SERVICE BULLETIN

No. 566

Piper Aircraft Corporation

Subject: Edo-Aire Mitchell Service Bulletin No. MB-13, dated May 3, 1977; Modification to Edo Aire Mitchell NSD-360 Horizontal Situation Indicator.

SKETCH "B" CD-106 PLUG
(View Of Plug With Cover Removed)

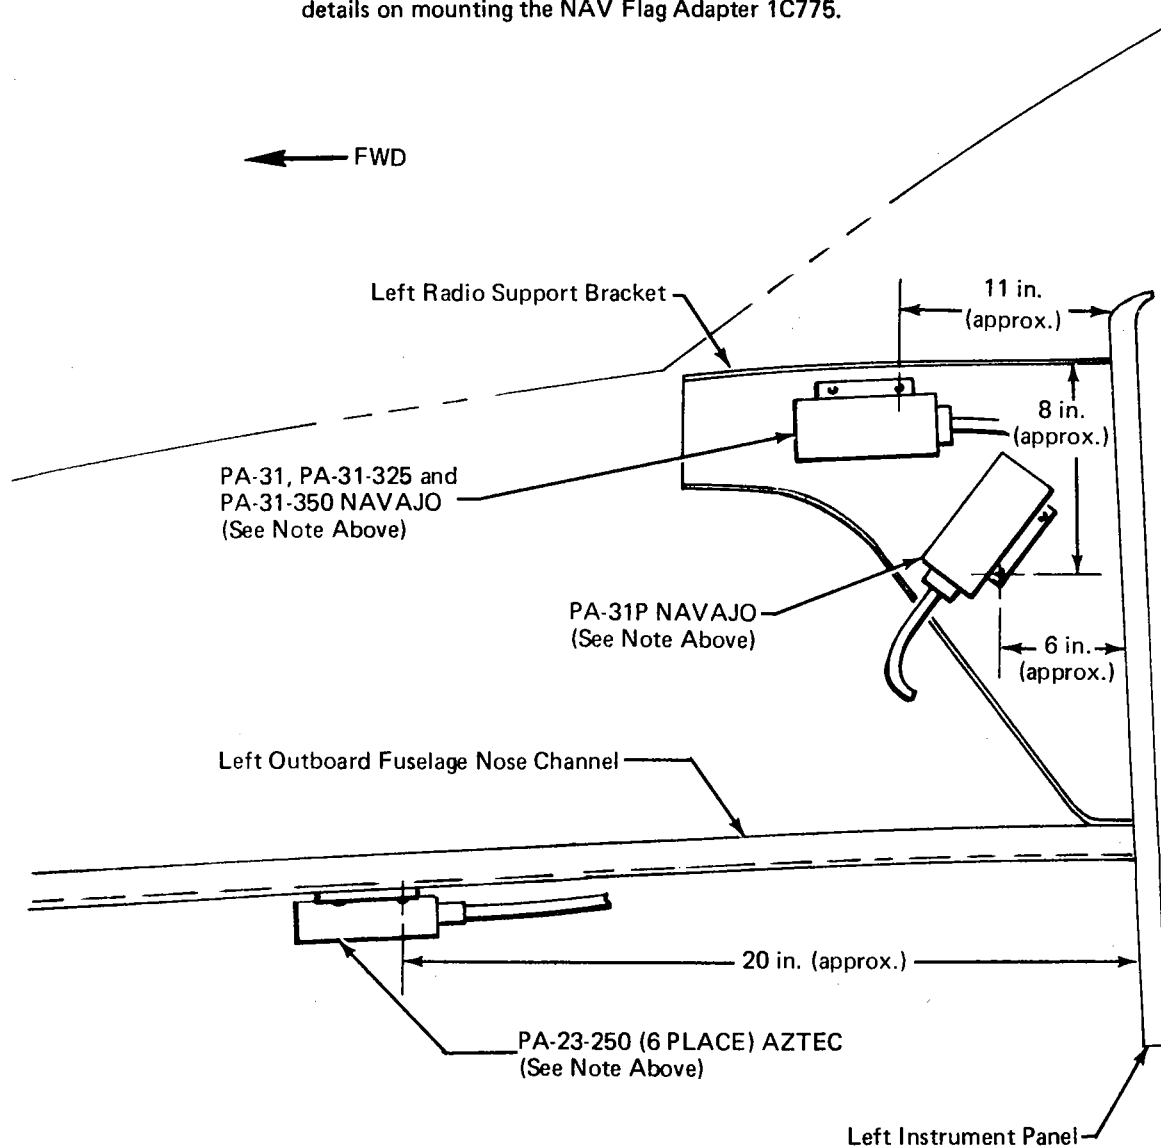
1. Wiring Instructions: Refer to Drawing 63D337-2, on Page eight of MB-13 for a pictorial representation of the following instructions: Also, refer to attached sketch "B" for supplemental view of CD-106 plug.
 - a. Disconnect plug CD-106 from rear of the NSD-360 unit and remove all necessary cable restraints for approximately eight inches to obtain sufficient cable freedom.
 - b. Locate the wire routed from pin seven of CD-106 and cut this wire approximately six inches from the plug. Locate the WHT/VIOLET wire in the 30C550 cable harness and attach it to the six inch wire leading from pin seven of CD-106. Use the 29S59 butt splice to make all connections.
 - c. Locate the WHT/BLK/VIOLET wire in the 30C550 cable and attach it to the other half of the wire that was attached to pin seven in "b", above.

- d. Locate the wire routed from pin eight at CD-106, and cut this wire approximately six inches from the plug. Locate the WHT/GRY wire in the 30C550 cable and attach it to the six inch wire leading from pin eight.

- e. Locate the WHT/BLK/GRY wire in the 30C550 cable and connect it to the other half of the wire that was attached to pin eight in "d", above.
 - f. Locate the wire routed from pin 33 of CD-106, and cut this wire approximately six inches from plug CD-106. Locate the WHT/ORG wire in the 30C550 cable and attach it to the six inch wire leading from pin 33.

- g. Locate the WHT/BLK/ORG wire in the 30C550 cable and connect it to the other half of the wire that was attached to pin 33 in "f", above.
 - h. Locate the wire routed from pin 34 of CD-106, and cut this wire approximately six inches from the plug. Locate the WHT/YEL wire coming from the 30C550 cable and attach it to the six inch wire leading from pin 34.

- i. Locate the WHT/BLK/YEL wire in the 30C550 cable and attach it to the other half of the wire that was attached to pin 34 in "h", above.
 - j. Connect the WHT/RED wire to the appropriate Nav Receiver circuit breaker. DO NOT connect it to the NSD-360 circuit breaker.

SKETCH "A" APPROXIMATE LOCATION OF NAV FLAG ADAPTER 1C775
(View Looking At Left Side Of Upper Forward Fuselage Section)

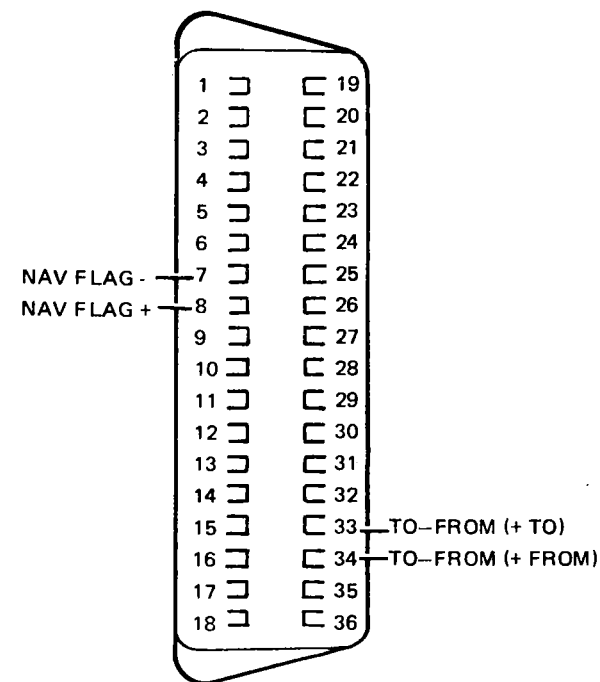
Refer to Sketch "A" of this service release for recommended Nav Flag Adapter unit location and installation.

NOTE: Refer to page two of Edo Aire Mitchell MB-13 for details on mounting the NAV Flag Adapter 1C775.

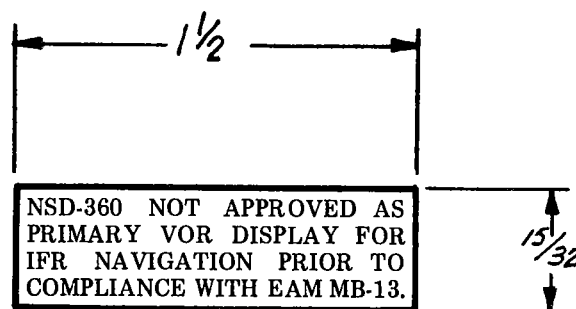
For the affected aircraft, Placard, P/N 13A895, must be installed on the instrument panel, as close as practical to the NSD-360 Navigation Instrument, prior to any further I.F.R. flight, or until the restriction is removed by installation of the NAV Flag Adapter, P/N 1C775.

Where Placard, P/N 13A895, is installed in lieu of NAV Flag Adapter, P/N 1C775, this service bulletin shall be placed with the aircraft service records, and a log book entry made to reflect compliance with Edo-Aire Mitchell Service Bulletin, MB-13. The placard is attached to this service bulletin, however, an additional placard may be obtained from Edo-Aire Mitchell at no charge if it is lost or destroyed.

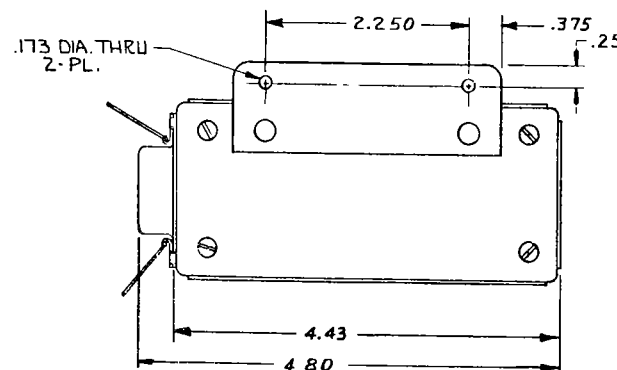
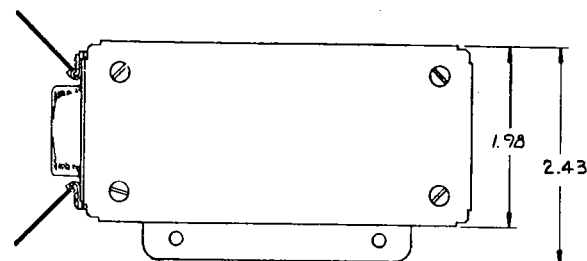
1. The 1C775 NAV Flag Adapter is a small light weight unit (0.3 lb.). It is to be mounted on existing structure between the instrument panel and forward cabin bulkhead or firewall, near the rear of the NSD-360 Navigation Instrument.

2. Using Drawing No. 1C775 as a guide, locate an area with sufficient space and structure to support the NAV Flag Adapter, and mark and drill two .173 dia. (No. 17 drill) holes.

3. Secure the unit to the aircraft structure, using two each of the 8-32 screws, washers, and nuts supplied with PKMB-13.
4. Drawing No. 63D337-2 shows the interconnect wiring between the NSD-360 navigation instrument and the 1C775 NAV Flag Adapter. The four wires indicated, which are a part of the cable bundle to CD-106 of the NSD-360, are to be intercepted as close as feasible to CD-106, and the leads of Adapter Cable, P/N 30C550, are to be connected as shown on Drawing No. 63D337-2. Plug the CD-151 Plug of the 30C550 Cable into the CD-151 Receptacle of the 1C775 NAV Flag Adapter. Route the cable to CD-106 of the NSD-360, leaving sufficient service loop to adequately secure the cable. Cut the wire leads to the proper length and connect to the NSD-360 cable leads as shown using eight 29S59 butt splices. The ground lead of the 30C550 Cable should be routed to a convenient airframe ground. The A+ lead should be connected to the circuit breaker of the navigation receiver that is associated with the NSD-360. Do not connect the A+ to the NSD-360 circuit breaker!
